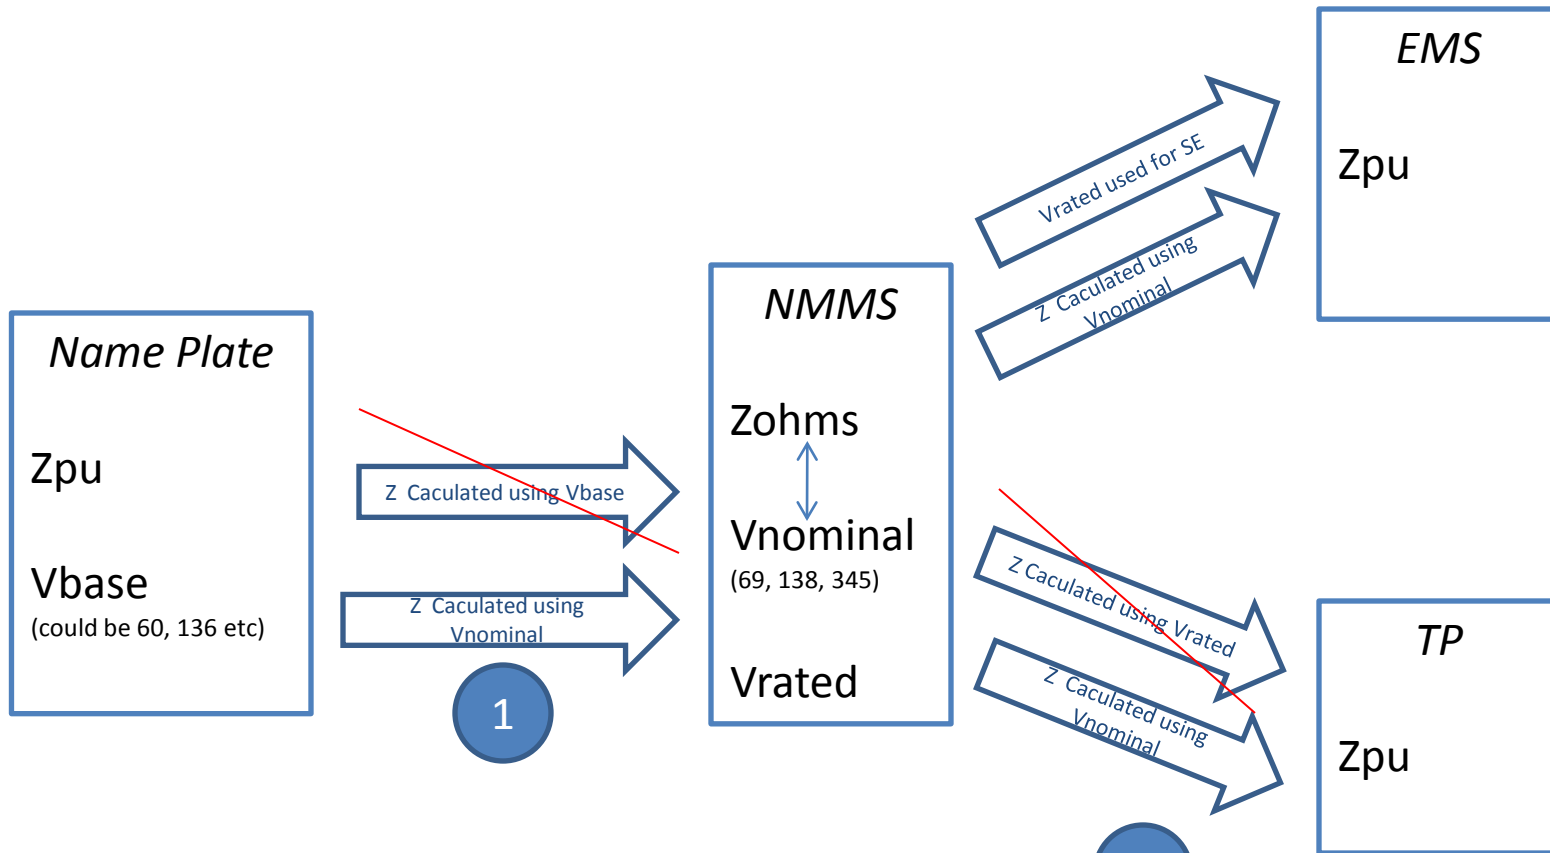
TSP calculation should always use Vnominal

TP uses Vnominal
